Re: Turkey Point Unit 4
Docket No. 50-251
Order (EA-03-009) Relaxation Request
Examination Coverage of Reactor Pressure Vessel Head
Penetration Nozzles

**TURKEY POINT UNIT 4 RELAXATION REQUEST
FROM US NRC Order EA-03-009**

Figure 1: RPV Nozzle # 11 UT Inspection "C" Scan with area of missed coverage identified the white oval at the low point of the weld.

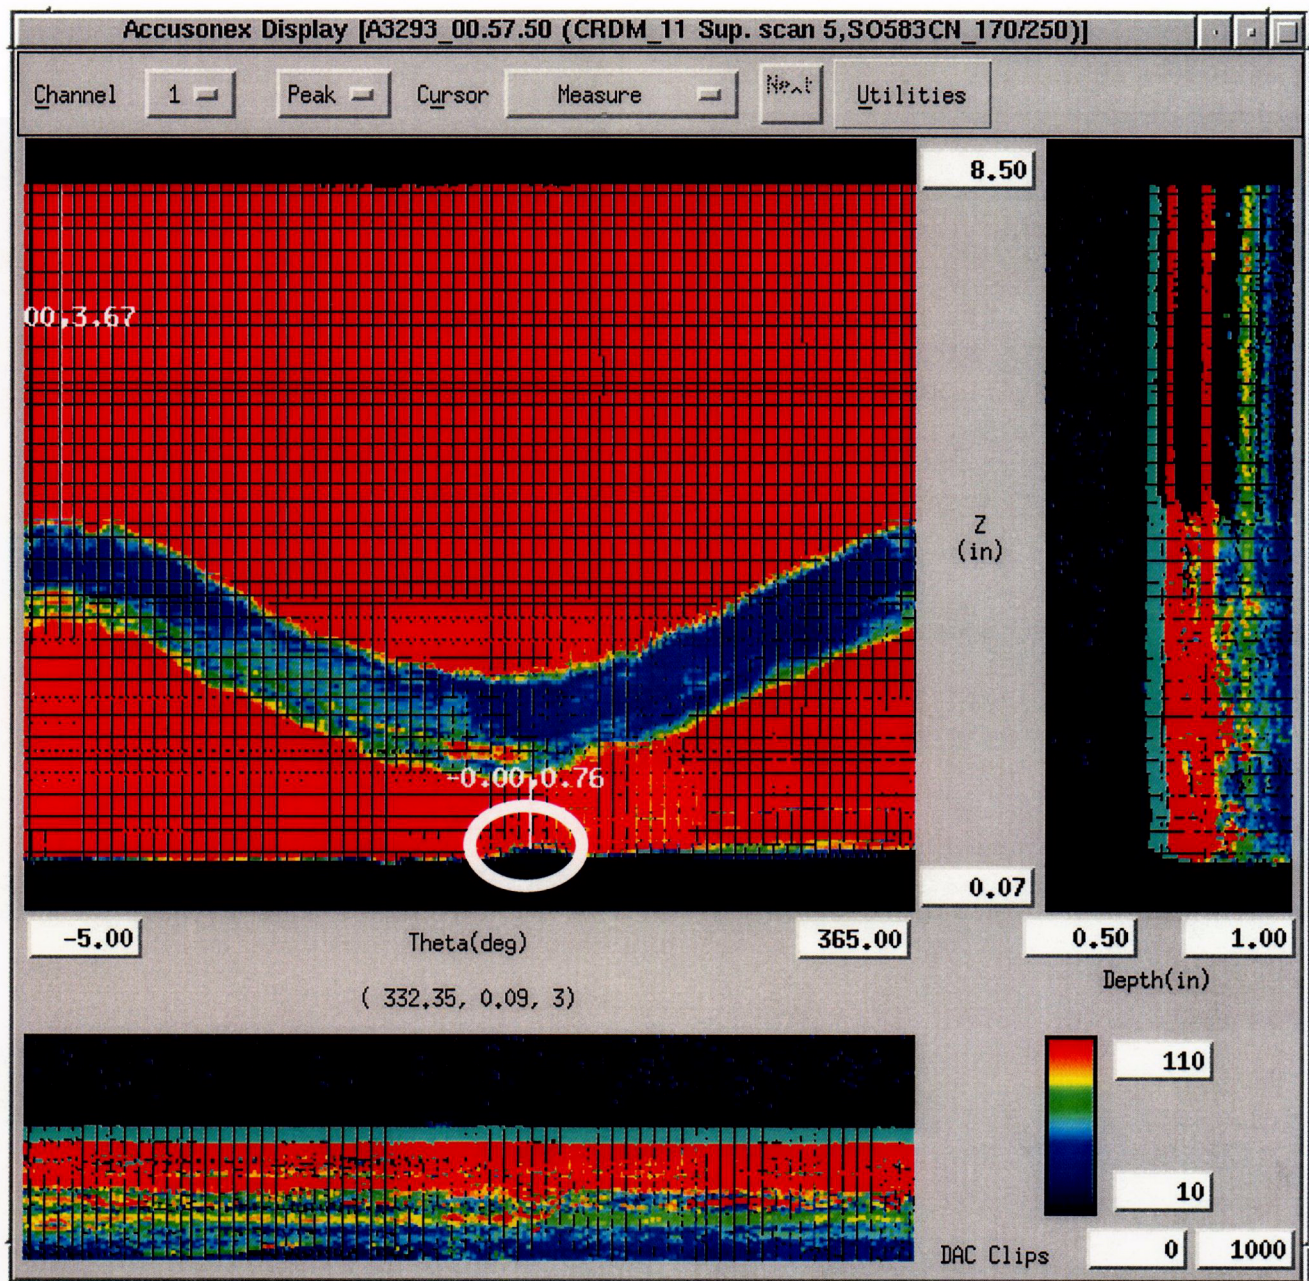
RPV head penetration # 11 contains an area of coverage less than that required by the NRC Order. The Order requires examination from 2 inches above the J-groove weld to the "bottom of the nozzle." The coverage below the weld, in the non-pressure boundary portion of the RPV head penetration nozzle, did not extend to the "bottom of the nozzle" for the full circumference. The actual area of missed coverage is a 32° arc, starting 0.76 inches below the bottom of the weld. A presentation of the UT coverage area, with the area of missed coverage identified, is shown in Figure 1.

The proposed alternative is to perform the UT examination to the lowest elevation that can be practically inspected. This is defined as "the examination shall be performed to include 2 inches above the weld to the lowest elevation possible or ≥ 0.62 inches below the weld, whichever is greater." This relaxation request documents and submits to the NRC, deviations from the NRC Order required inspection coverage area along with a justification as to their acceptability.

Figure 2: Through-Wall Axial Flaws Located in the 42.6 Degree Row of Penetrations, Uphill Side - Crack Growth Predictions (From Figure 6-19, WCAP-16027-P)

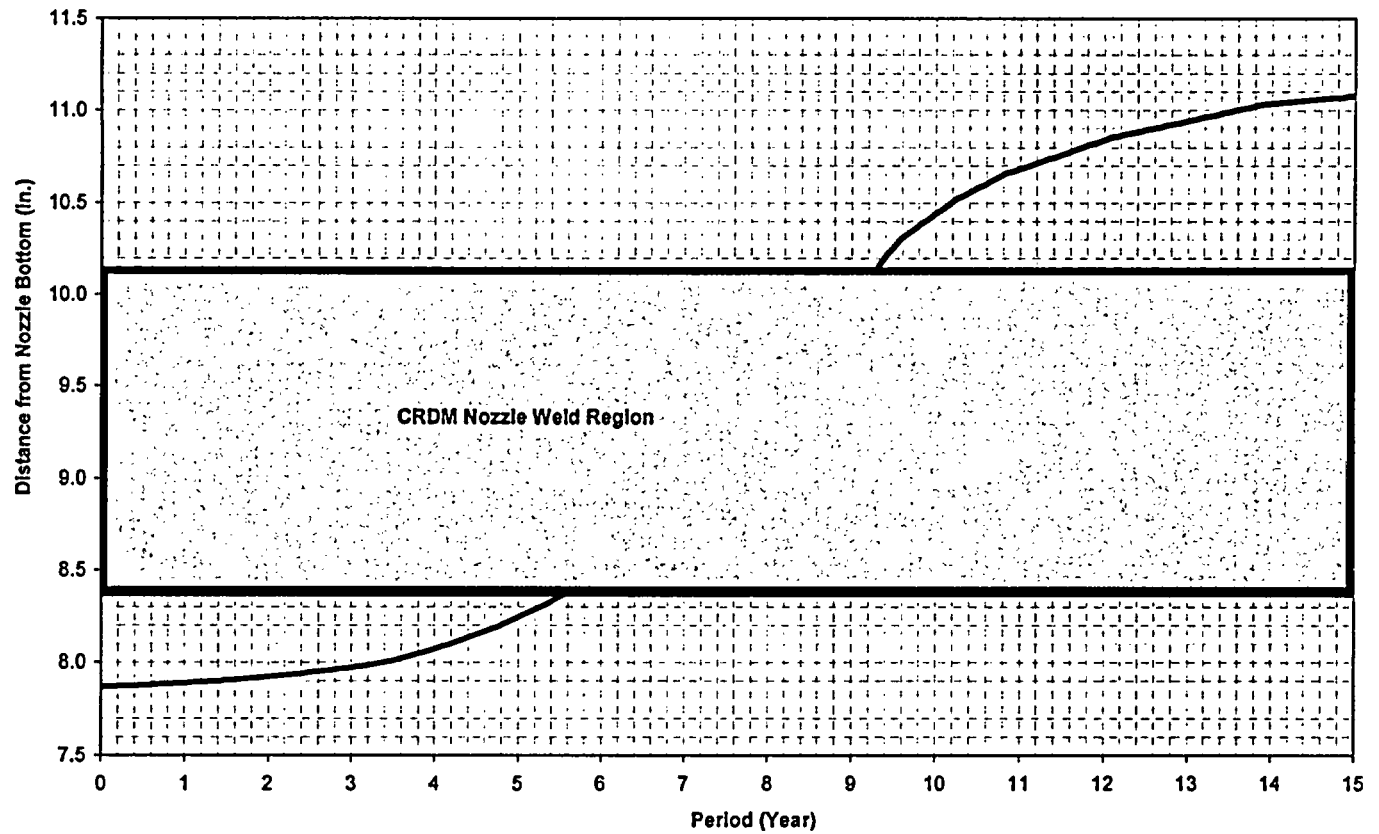
To determine the significance of an axial flaw that is contained in the non-pressure boundary nozzle material in the un-inspected region greater than 0.62 inches below the weld, a flaw tolerance approach is used. A flaw evaluation was performed postulating an axial flaw in the area of missed coverage below the weld using WCAP-16027-P.³ A through wall flaw is postulated in the nozzle material from the bottom of the penetration to 0.62 inches from the bottom of the weld. This is a conservative assumption since the inspected region extends 0.39 inches farther below the weld on the ID surface of the nozzle. The flaw evaluation in WCAP-16027-P is based on Turkey Point Unit 3 and 4 specific stresses in the nozzle penetrations. Since the stresses in the region greater than 0.62 inches below the weld are too low to propagate an axial flaw, the WCAP-16027-P flaw evaluations start at ½ inch below the weld, and evaluate the time to propagate the flaw in the nozzle to the bottom of the weld (start of the pressure boundary portion of the nozzle material or toe of the J-groove weld). Assuming a through wall flaw below the weld, with the flaw end located at ½ inch below the weld (which is in the area of complete UT examination coverage), an axial flaw would take greater than 5 years of operation (Figures 6-12 through 6-20 in WCAP-16027-P) in any nozzle location to grow to the point of contact with the weld. This time period is significantly greater than the current inspection frequency of every refueling cycle (18 months for Turkey Point Unit 4) identified in NRC Order EA-03-009. As an added conservatism, this evaluation does not attempt to evaluate the time for the axial flaw to grow from the bottom of the weld through the pressure boundary. Figure 2 provides a graphical presentation of the

above flaw evaluation discussion for the outer most penetration location (most limiting case).

Therefore, there are no concerns with the structural integrity of the Turkey Point Unit 4 RPV penetration nozzles that could be caused by axial cracking in the missed coverage areas in the non-pressure boundary portion of the nozzle material greater than 0.62 inches below the weld for a period of greater than 5 years of operation.
